COMMENT: 20-05. Neighbors for Smart Rail.

From: Colleen Mason [cmasonheller@yahoo.com]
Sent: Monday, October 26, 2009 3:33 PM
To: Diaz, Roderick
Cc: crenshaw@fixexpo.org
Subject: Crenshaw Corridor Transit Project DEIR Comments
Attachments: NFSR Crenshaw Corridor.pdf

Thank you for the opportunity to comment on the Crenshaw Corridor Transit Project (Crenshaw Line or “the project”). Neighbors for Smart Rail (NFSR) submits this letter in response to the draft environmental impact report (DEIR) for the project hereby requests that these comments be included in the administrative record.

Fig. 3: From the Tysons Tunnel feasibility study available at TysonsTunnel.org

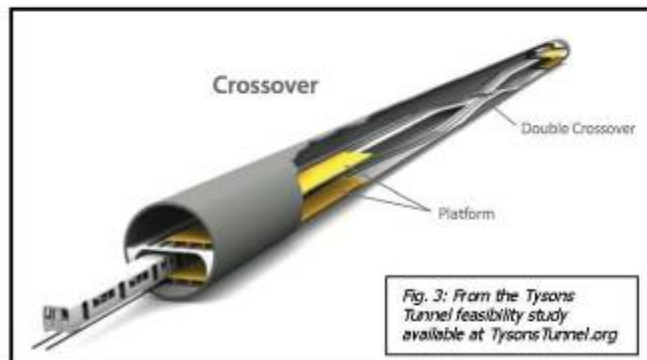
Single large bore tunnel should be considered.

The DEIR/S fails to consider a large bore tunnel, where one tunnel boring machine is used to construct a single large tunnel for both tracks, as opposed to two smaller separate tunnels with one track each (known as twin bore tunnels). Among other impacts, a single large bore tunnel would mitigate the congestion and air quality impacts associated with crossover construction, which typically requires cut-and-cover construction (the crossover can be constructed within a large bore tunnel). Coupled with reduced required manpower and other benefits, single large bore tunnel often results in a significant overall capital cost savings.

A single large bore tunnel can also reduce the surface level footprint of the cut-and-cover station box by at least 5,000 square feet, by placing the platform within the tunnel, mitigating among other impacts congestion and air quality.
